ADDENDUM NO. 07

October 16, 2023

Northwestern School Corporation – Multiple Projects
3431 County Rd N 400 W
Kokomo, IN 46901

5. SHEET 1-ED1D1 – 1 – ELECTRICAL DEMOLITION PLAN – UNIT D (see attached sheet)

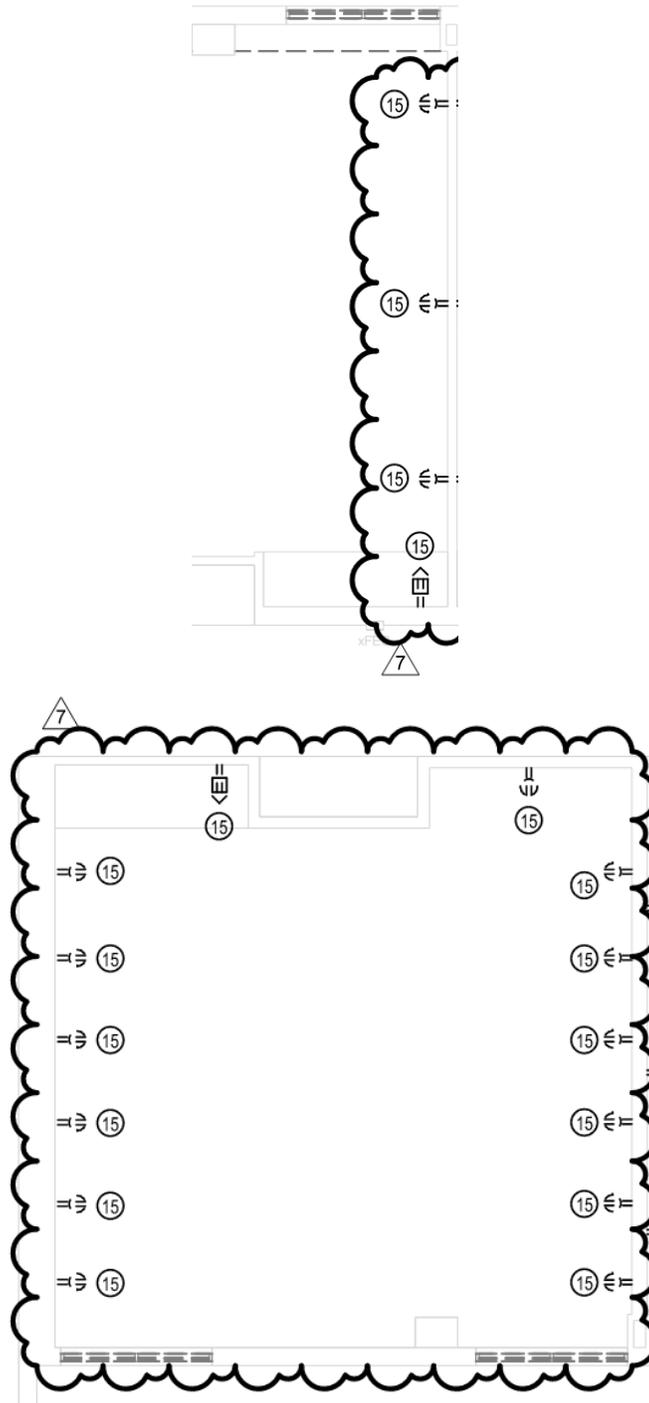
- a. Added more receptacles to be demolished in each classroom. See two snip-its; first is typical of (8).
Second snip-it is typical of (1).
- b. Revised plan note #15 to say "Existing receptacle and wiremold to be removed. Existing circuit to remain above the ceiling for extension to new devices. Refer to new work on power and systems plans for additional information."

12. **SHEET 2-ED1J1 – 2 – ELECTRICAL FIRST FLOOR DEMOLITION PLAN – UNIT J**

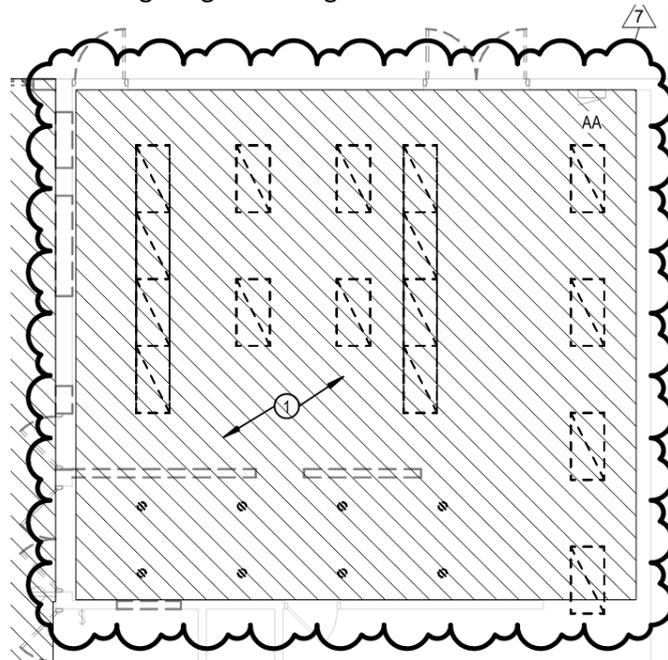
- a. Additional demo lighting in Serving Room.

13. SHEET 2-EL1B1 – 2 – FIRST FLOOR LIGHTING PLAN – UNIT B (see attached sheet)

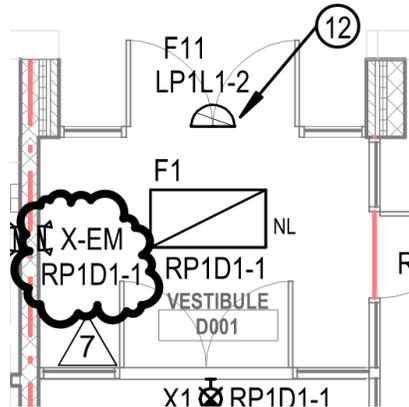
- a. Added (1) 'X-EM' emergency light to room B115.
- b. Added (4) 'X-EM' emergency lights to corridor B004.

16. SHEET 2-EL1E1 – 2 – FIRST FLOOR LIGHTING PLAN – UNIT E

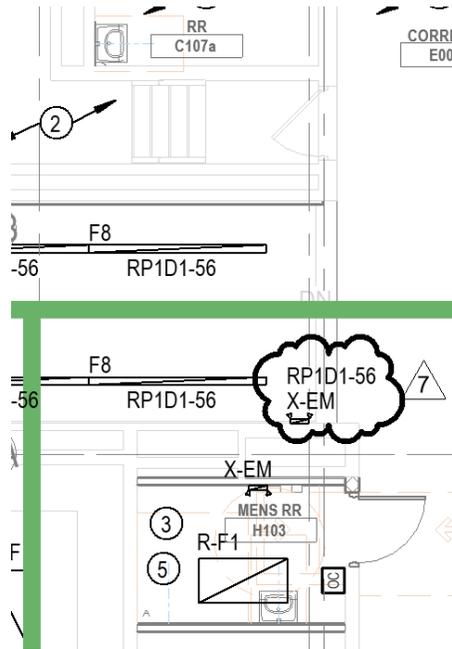
- a. Added (1) 'X-EM' emergency light to corridor B004.

17. SHEET 2-EL1J1 – 2 – FIRST FLOOR LIGHTING PLAN – UNIT J

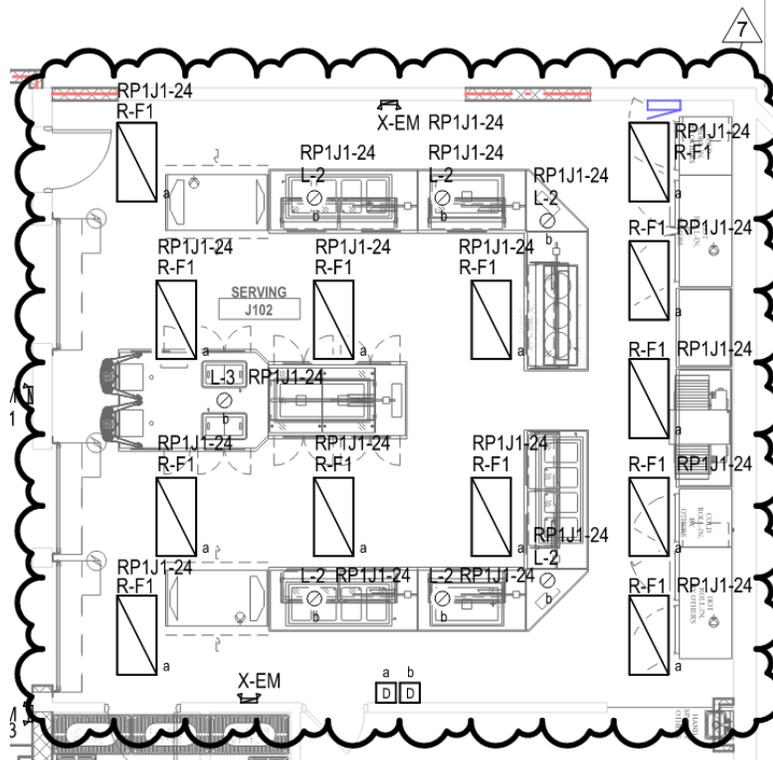
- a. Revised plan note #13 to say “Wall sconces provided and installed by serving line manufacturer.”
- b. New general lighting and emergency lights in Serving Room J102.

18. SHEET 2-EL1L2– 2 – SECOND FLOOR LIGHTING PLAN – UNIT L (see attached sheet)

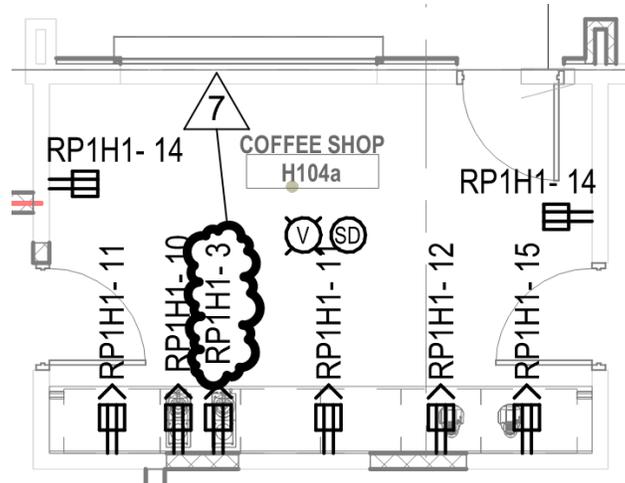
- a. Added annotation tag to (1) 'X-EM' emergency light.
- b. Removed floating emergency lights that were showing up from the first floor.

21. SHEET 2-EP1J1 – 2 – FIRST FLOOR POWER & SYSTEMS PLAN – UNIT J

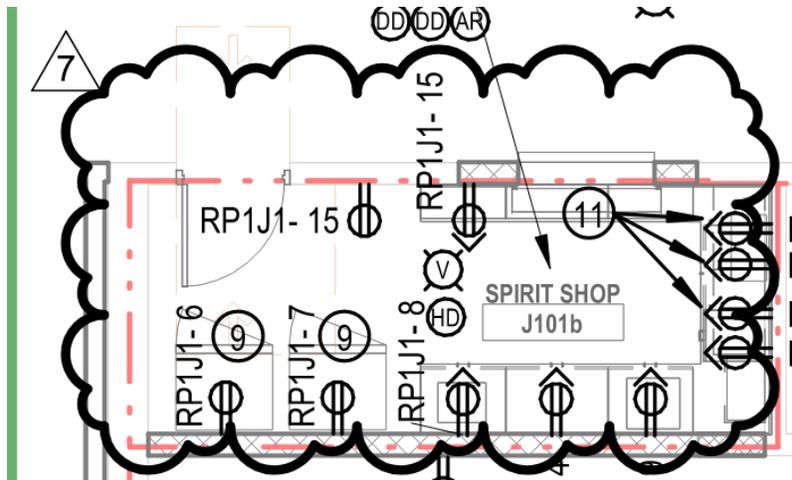
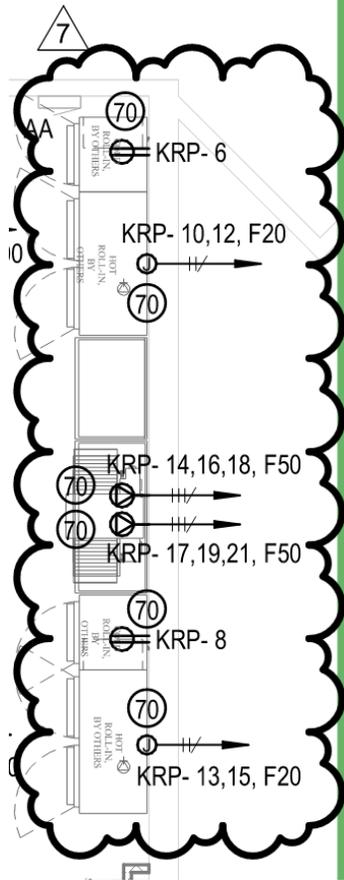
- a. Relocated receptacles for refrigerators in room J101b.
- b. Added plan note #70 “Refer to food service drawings for rough-in heights.”

22. SHEET 2-E-601 – 2 - ELECTRICAL SCHEDULES (see attached sheet)

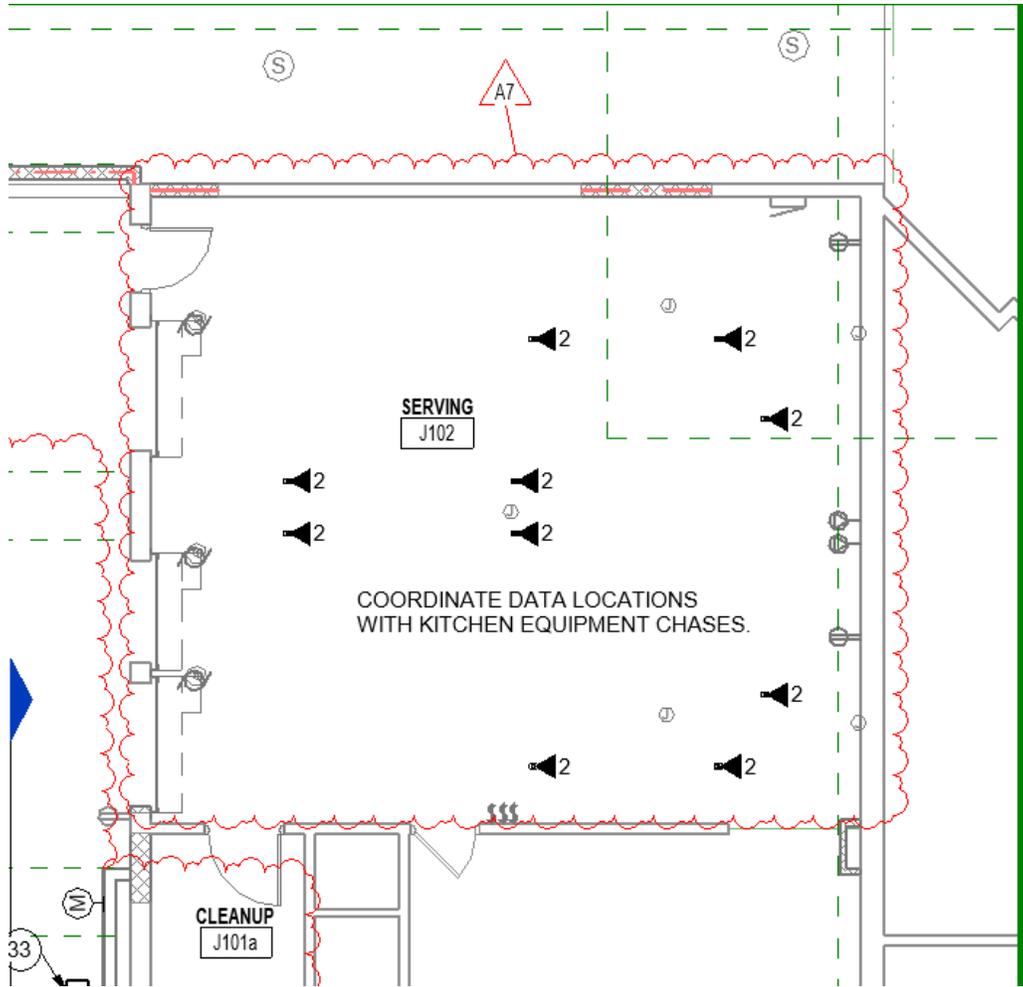
- a. Revised light fixture schedule to show all light fixtures at 5000 K.
- b. Additional manufacturer information for fixture type 'L-3'.

B. Drawing Number 2-TF1J1

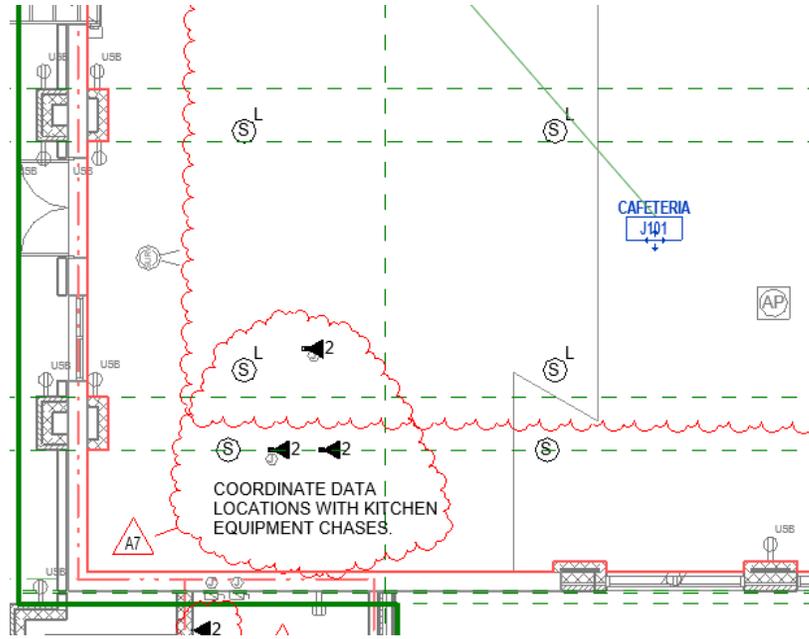
1. MODIFY Drawing as follows:

C. Drawing Number 1-TF1A1

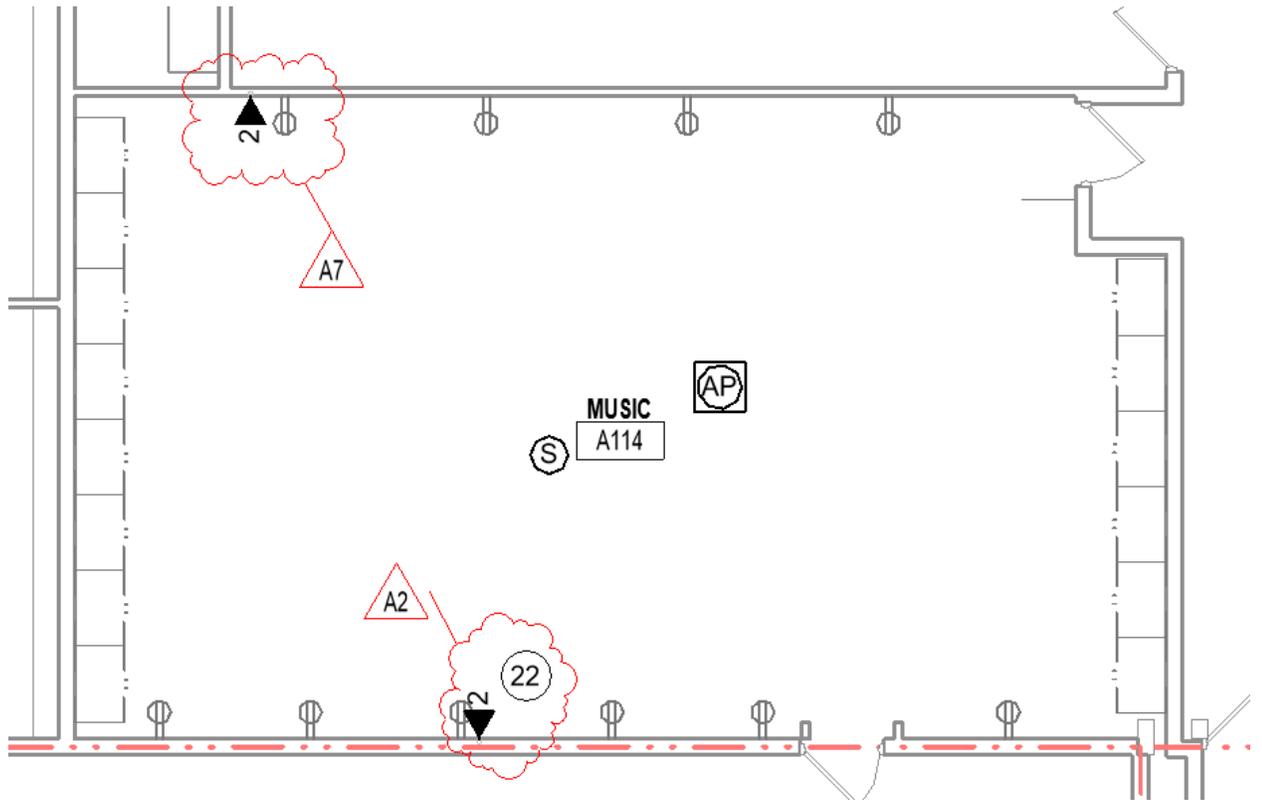
1. MODIFY Drawing as follows:

D. **Drawing Number 2-TF1F1**

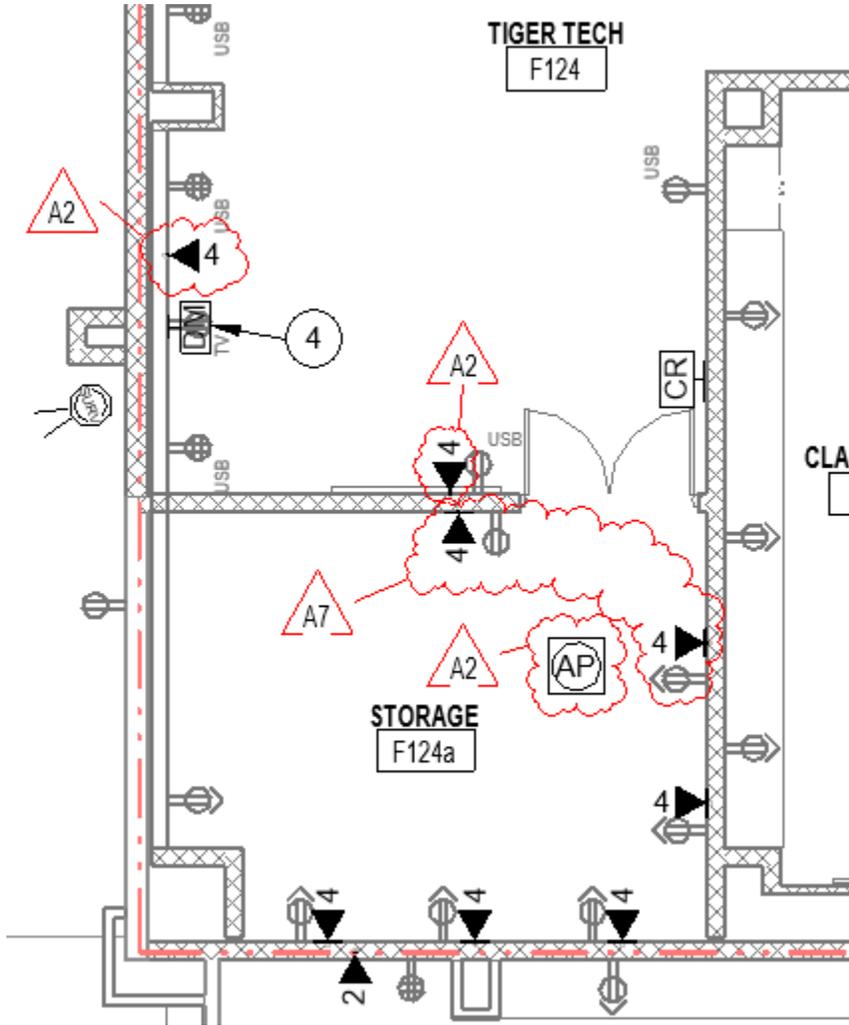
1. MODIFY Drawing as follows:

E. **Drawing Number 1-TF1B1**

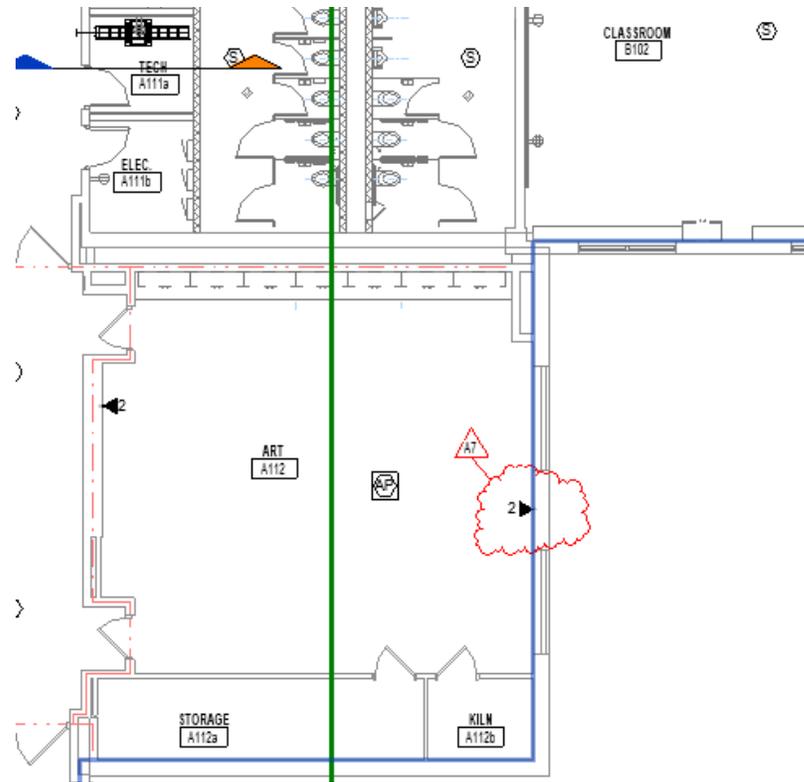
1. MODIFY Drawing as follows:

F. Drawing Number 1-TF1C1

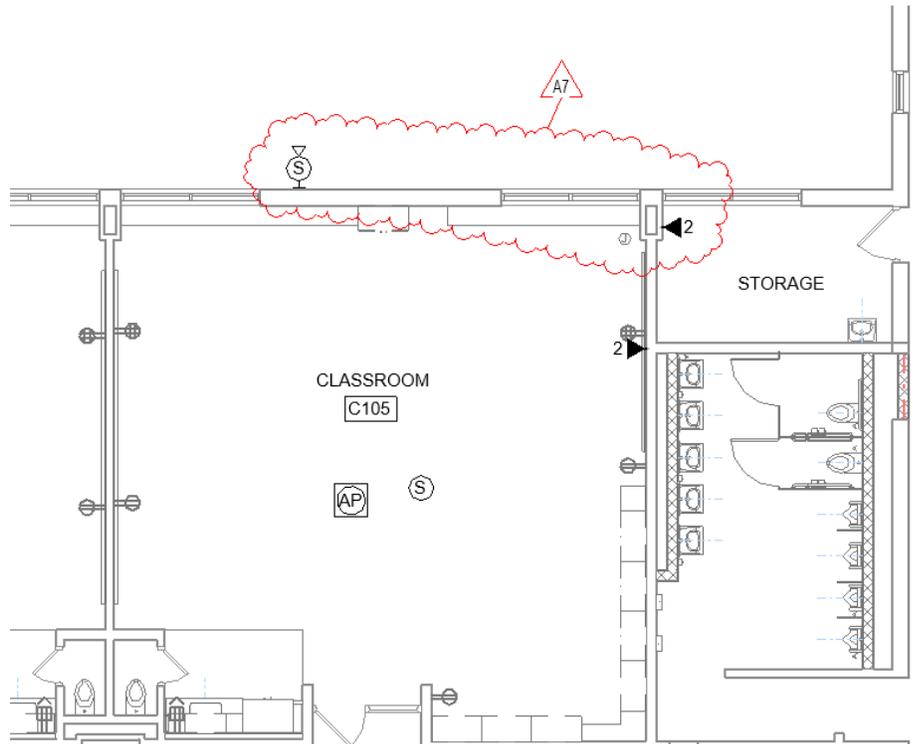
1. MODIFY Drawing as follows:

G. **Drawing Number 1-TF1D1**

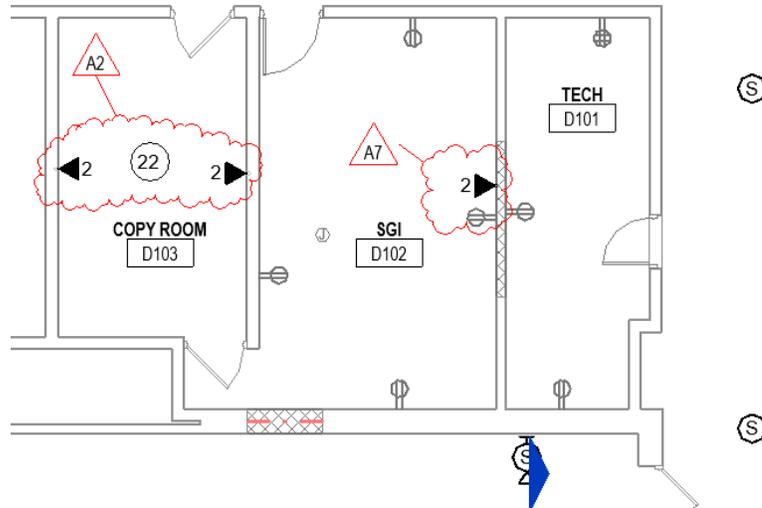
1. MODIFY Drawing as follows:

H. **Drawing Number 1-TF1D1**

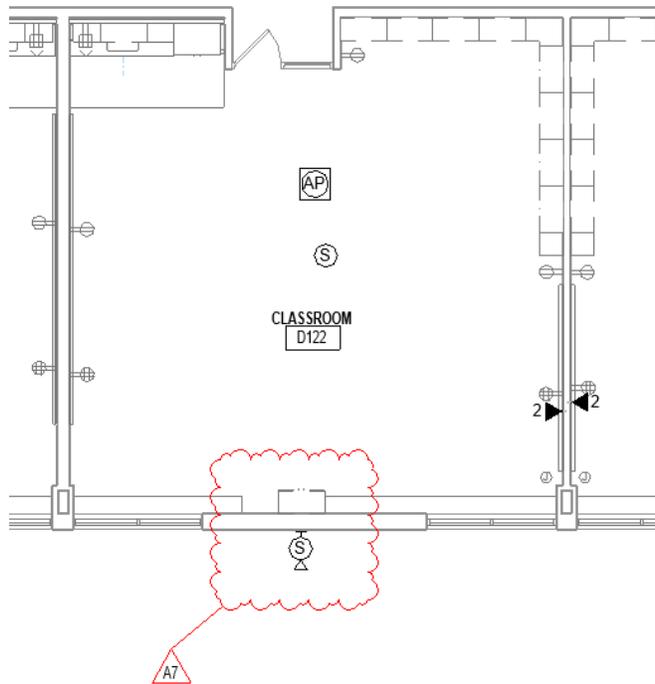
1. MODIFY Drawing as follows

I. **Drawing Number 2-TF1D1**

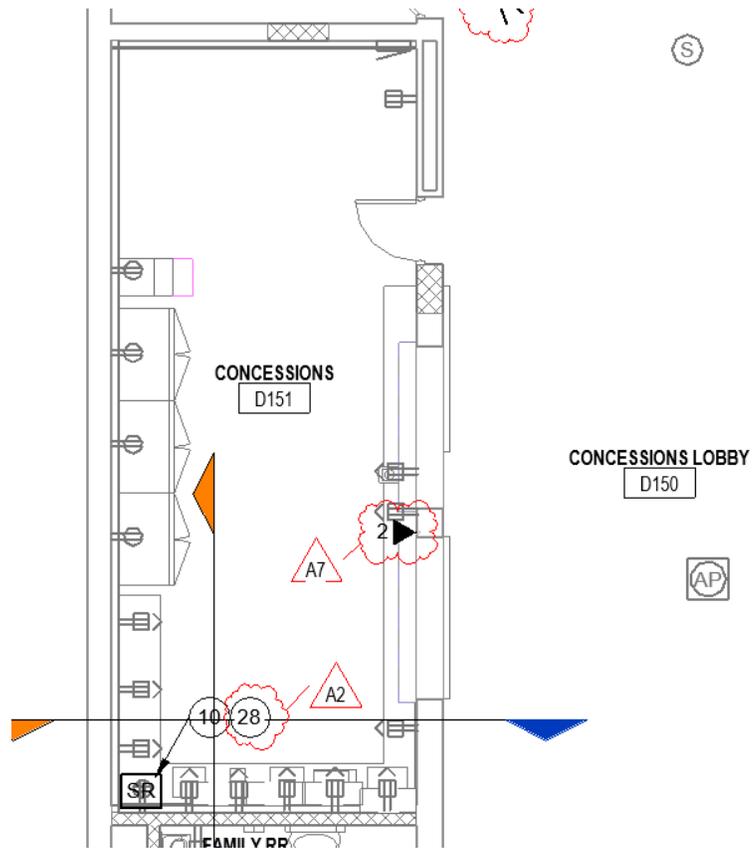
1. MODIFY Drawing as follows:

J. Drawing Number 2-TF1E1

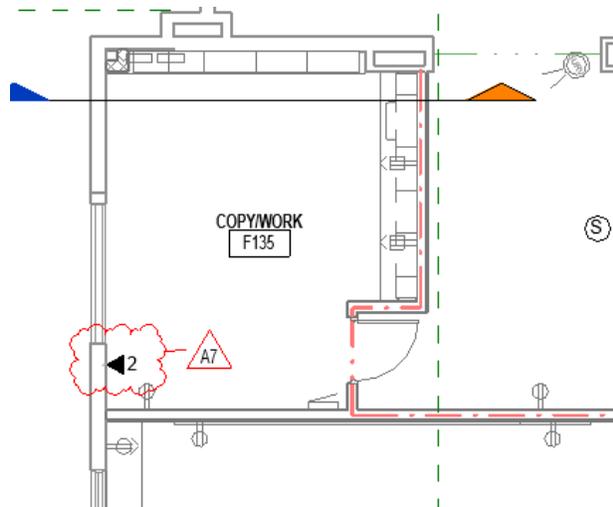
1. MODIFY Drawing as follows:

K. Drawing Number 2-TF1H1

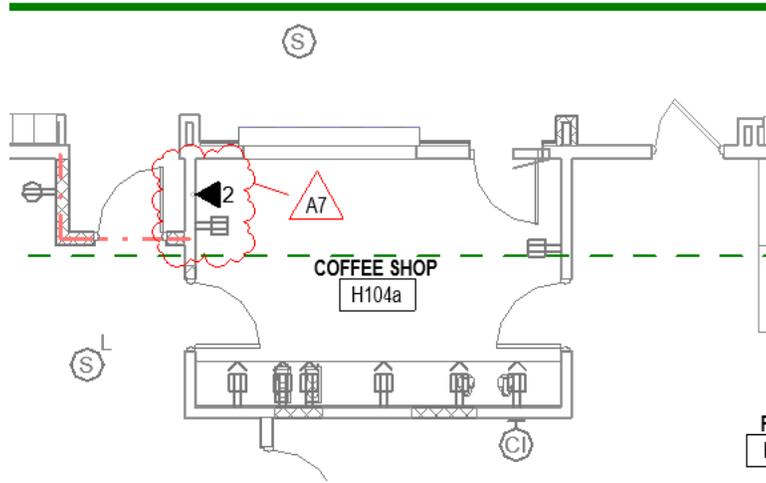
1. MODIFY Drawing as follows:

M. **Drawing Number 2-TF1G2**

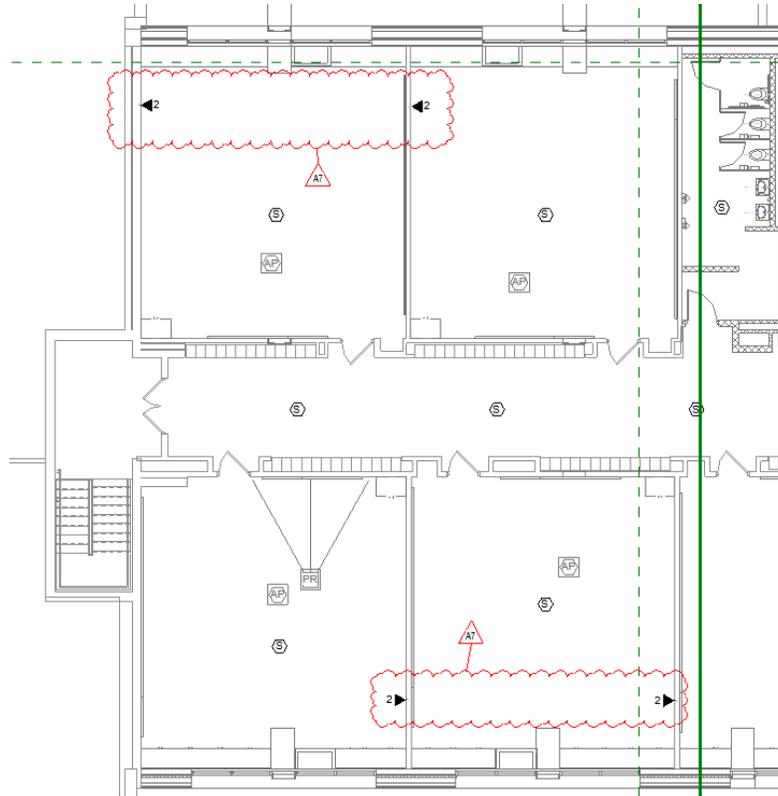
1. MODIFY Drawing as follows:
